Interactive comment on “Exploiting the information content of hydrological “outliers” for goodness-of-fit testing” by F. Laio et al.

Referee 1 is gratefully acknowledged for his/her insightful comments. In the following, the responses to the question he/she raised are reported.

Fig. 1. Power of the classical (stars) and modified (circles) maximum value test for different sample sizes (n) for a case when a Gumbel distribution is used both as parent and hypothetical distribution

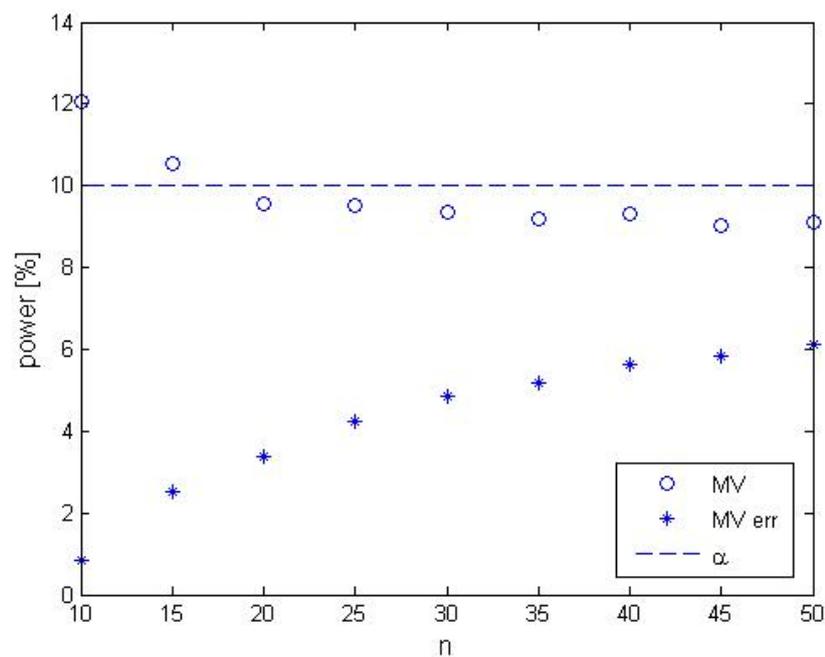
1) The point raised by Referee 1 on the rigorousness of the statement at page 4850, lines 5-7 is a very good one. In fact, while the independence of new parameters estimators on $x_{(n)}$ is preserved asymptotically, some residual dependence persists for sample sizes of the same order of magnitude of the ones that we consider. We will better specify this part of the paper (also lines 4862: 12-14) by suitably modifying the text and adding a reference to the paper pointed out in the Referee’s comment. However, this aspect has a minor effect on the result that we present in the manuscript. This is

demonstrated in the graph reported hereinafter (Fig. 1), where the power of the classical and modified maximum value test are represented for different sample sizes for a case when the same distribution (a Gumbel distribution) is used both as the parent and as the hypothetical distribution. If the test statistic were completely independent of $x_{(n)}$, the power of the test would have converged to the significance level for any sample size (10% significance level, dashed line in the graph), because the hypothetical distribution coincides with the parent. On the contrary, it is observed that the power of the test is systematically below the significance level for the MV test applied with the classical L-moments estimators (MV err in the graph), which are heavily dependent on $x_{(n)}$, while the performance improves significantly for the modified test (MV). The effect of the residual dependence on $x_{(n)}$ pointed out by Referee 1 is probably responsible for the tendency of the test power to remain slightly below the significance level. This effect, however, is negligible for practical purposes. Similar results are obtained when using other distributions as parents.
